UTILITY PANEL UP-204 (CKT #2095)

MARK	DATE	DESCRIPTIONS	BY	CH'D	CCO#
(1)	03/30/09	SERVICE PLATFORM ELECTRICAL CHANGES	RR MP	RG FW	55

DETAILS
SAS SUPERSTRUCTURE ROADWAY EASTBOUND PANEL UP-204 SCHEDULE
NO SCALE

E-150

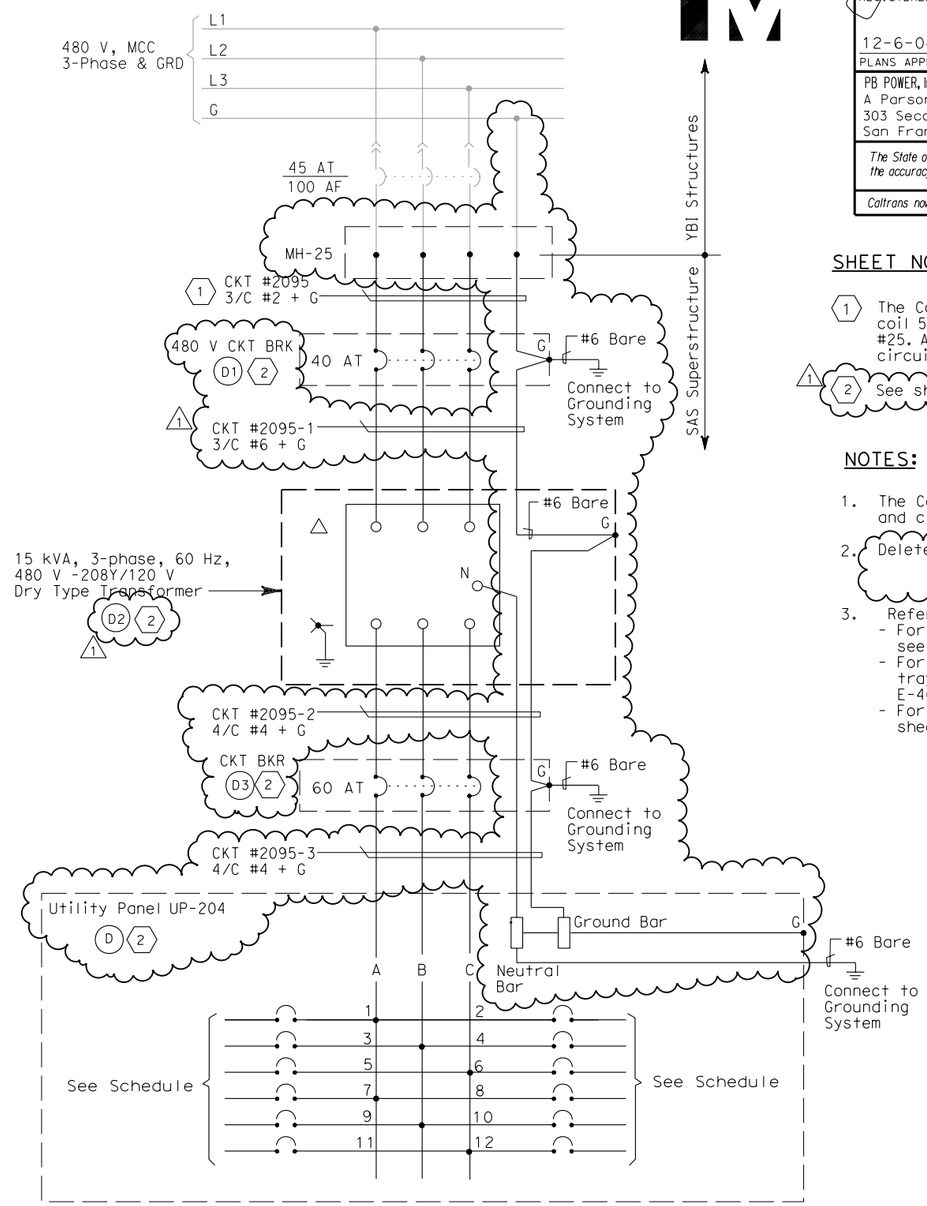
(1) The Contractor shall extend and coil 5.0 meters of cable in manhole #25. All cables shall be tagged with circuit numbers as shown.

(1) (2) See sheet E-71 for Equipment Schedule.

1. The Contractor shall provide nameplates and circuit schedules as shown.
2. Deleted. (1)
3. References:
   - For LVCC-B single line diagram, see sheets E-32 thru E-34.
   - For circuit and conduit/cable tray schedules, see sheets starting at E-401.
   - For pull box schedule, see sheet E-169.
